Appendix Q-3 – Details of Refinements to the Proposed Scheme – Refinements at the MIND Centre and Grounds

Great Yarmouth Third River Crossing Further Consultation on Scheme Proposals at the Community Roots at Mind Site Briefing Note to Accompany Drawing No's PKA018-MP-106 and PKA018-MP-107

2.0 Drawing No PKA018-MP-106

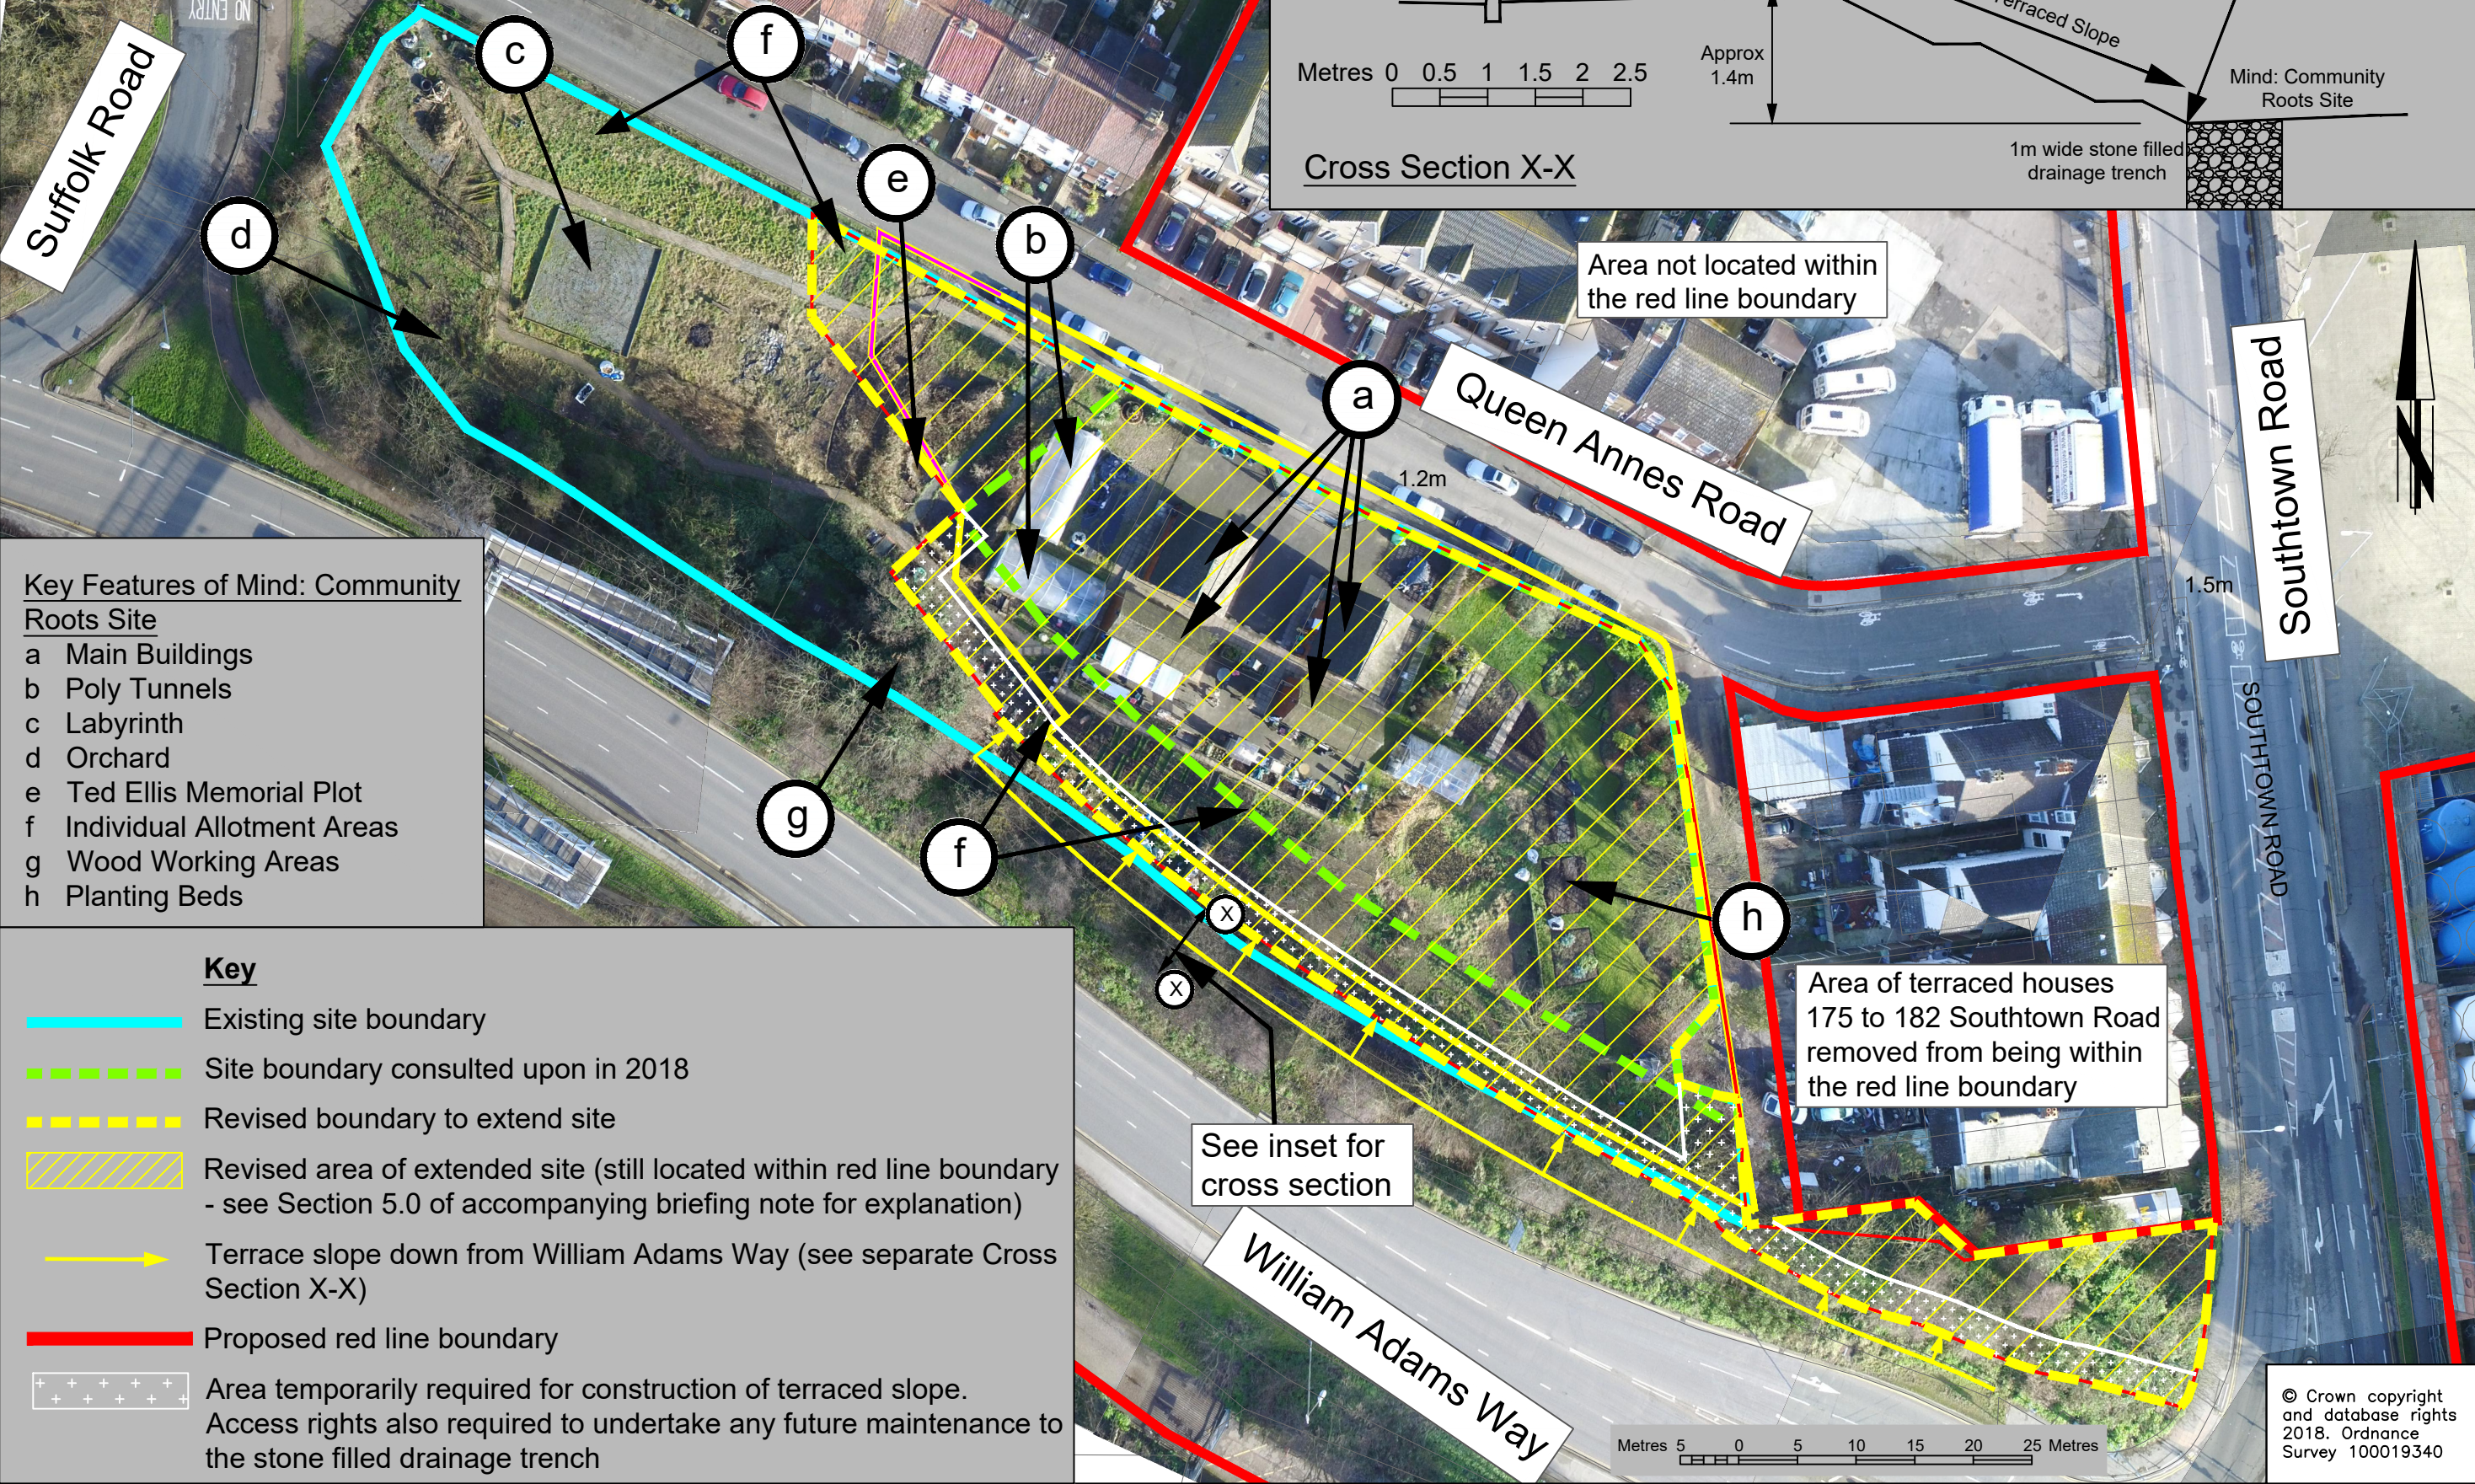
This drawing shows an aerial photograph of the Community Roots at Mind site. Key features within the site are shown, together with the current existing site boundary and the boundary resulting from the Scheme as previously presented by the 2018 consultation.

The hatched area shows an updated Scheme boundary that the Council is now consulting upon. This reduces the impact of the Scheme proposals on the Community Roots at Mind site and provides for a greater area for the main site to be retained compared to that previously proposed. The increased site area would be achieved by:

- Removing the originally proposed drainage ditch on the south side of the site, together with changing the terraced embankment slope between William Adams Way and the Community Roots at Mind site. A typical cross section showing this terrace slope is provided on the drawing (see Cross Section X-X). The slope could be planted as part of the Scheme proposals and, subject to agreement, could be maintained by Community Roots.
- Changing the position of the vehicle turning head at the end of Queen Anne's Road (see Drawing No PKA018-MP-107), which enables the extension of the main Community Roots at Mind site further to the west.
